SUBJECT: SUMMARY OF JANUARY 16, 2013, HOLTEC INTERNATIONAL, INC.
MEETING FOR THE HI-STORM 100 CASK SYSTEM, AMENDMENT
REQUEST NO. 9 ON THERMAL ANALYSIS (TAC NO. L24476)

NRC Review of Holtec's Thermal Analysis of On-Site Transfer of the MPC

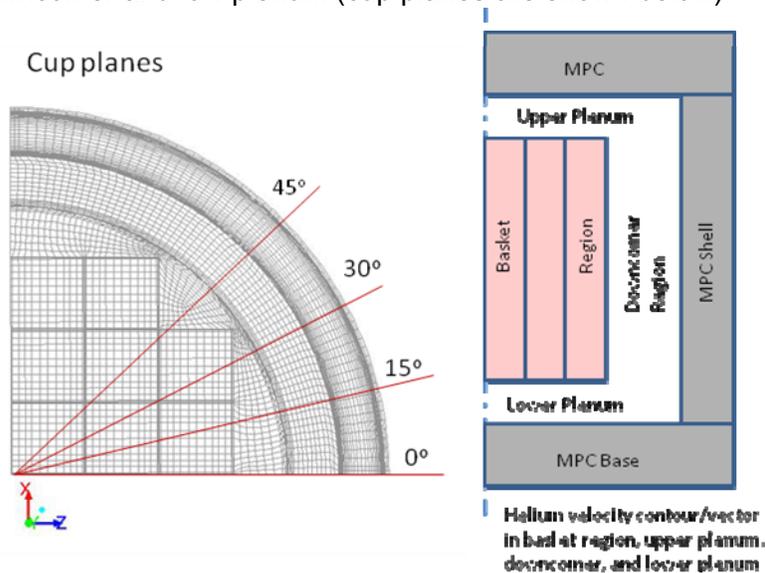
For example, the staff performed some sensitivity calculations in the use of effective thermal conductivity in the air gap between the MPC and the transfer cask. The FLUENT model provided by Holtec was modified to represent the air gap to allow air motion as well as heat transfer by conduction and radiation. The water density in the water jacket was represented by using water density as a function of temperature. With these changes, the staff obtained a peak cladding temperature of 745°F as compared to Holtec's result of 738°F for the bounding case (X=3) and an ambient temperature of 110°F. The PCT predicted by the staff is below the allowable limit but this result does not include the discretization error or the application error, as explained later.
